STAFF REPORT
COMMUNITY DEVELOPMENT DEPARTMENT

HEARING DATE: August 10, 2021

SUBJECT: H-2021-0035 – TM Creek Apartments
Phase 3

B. Site Plan (date: 4/30/2021)

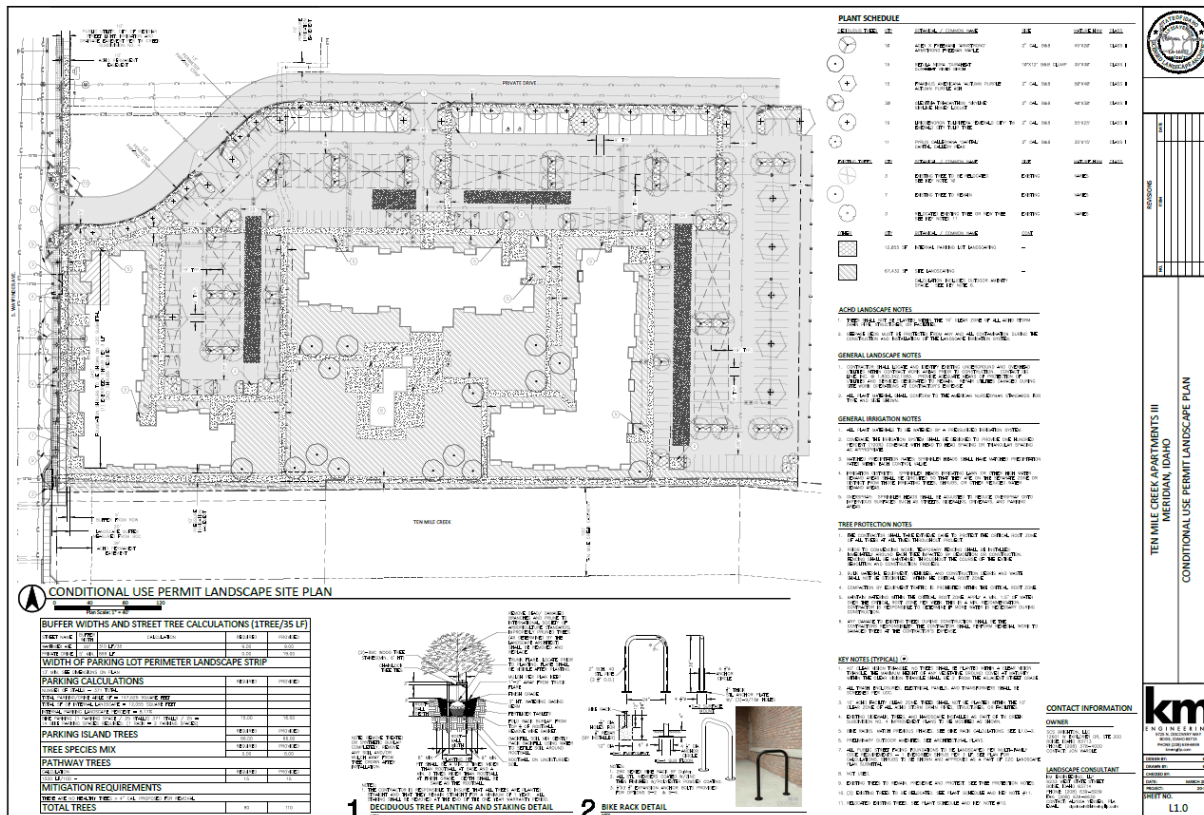
4. The site and/or landscape plan submitted with the Certificate of Zoning Compliance shall be revised as follows:
 - a. Depict the locations of the property management office, maintenance storage area, central mailbox location (including provisions for parcel mail, that provide safe pedestrian and/or vehicular access), and a directory and map of the development at an entrance or convenient location for those entering the development in accord with UDC 11-4-3-27B.7.

- b. All transformer and utility vaults and other service areas shall be located in an area not visible from a public street, or shall be fully screened from view from a public street in accord with UDC 11-4-3-27B.2.

- c. Depict landscaping along the foundations of all street facing elevations adjacent to S. Wayfinder Ave. as set forth in UDC 11-4-3-27E.2.
 - d. Include a detail of the proposed site amenities.

- e. Depict a gate across the emergency access driveway from W. Franklin Rd. as required by the Fire Dept.
 - f. Depict landscaping along the pathway adjacent to the southern boundary of the site per the standards listed in UDC 11-3B-12C, which require a *mix* of trees, shrubs, lawn and/or other vegetative groundcover.

- h. Widen the pathway along the southern boundary of the site to 10-feet.
 - i. Internal pedestrian walkways are required to be distinguished from the vehicular driving surfaces through the use of pavers, colored or scored concrete, or bricks per UDC 11-3A-19B.4b.

D. Qualified Open Space (dated: 5/3/21)

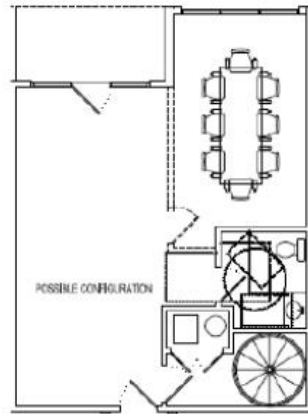
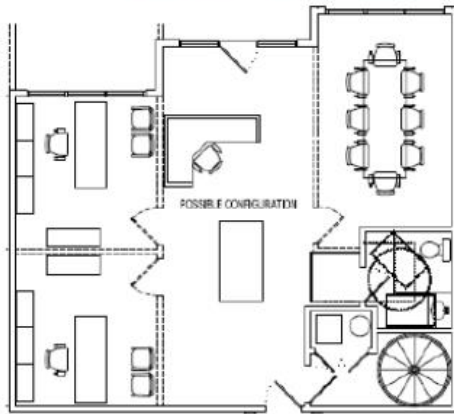
2. Common open space shall be not less than four hundred (400) square feet in area, and shall have a minimum length and width dimension of twenty feet (20'). *The common open space areas depicted on the open space exhibit in Section VIII.D meet this requirement.*

- g. Calculations should be included in the calculations table demonstrating compliance with the required landscaping in common open space areas per UDC 11-3G-3E.
